SERVICE BULLETIN

OCTOBER 24 1995

PRODUCT UPDATE: FUEL TANK, HEAT SHIELD

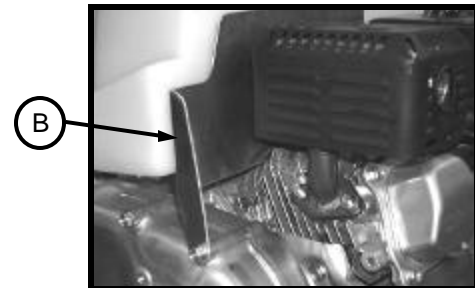
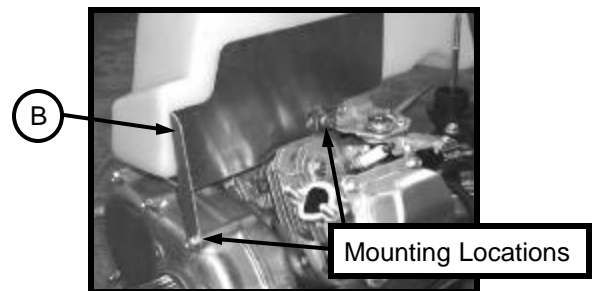
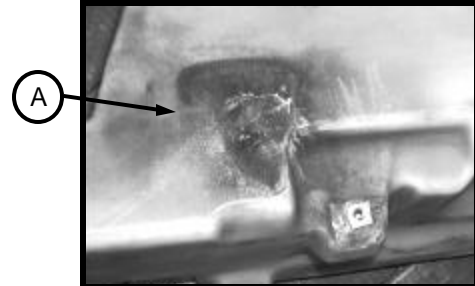
The fuel tank area at rear of muffler becomes soft and/or develops a leak.

The muffler deflector may restrict exhaust flow from muffler causing excess heat which can distort fuel tank and in extreme cases contact muffler. If this should occur, fuel tank can become soft and could result in a rupture [A].

Install Heat Shield immediately [B].

Fuel Tank, Heat Shield: **Part#00111**
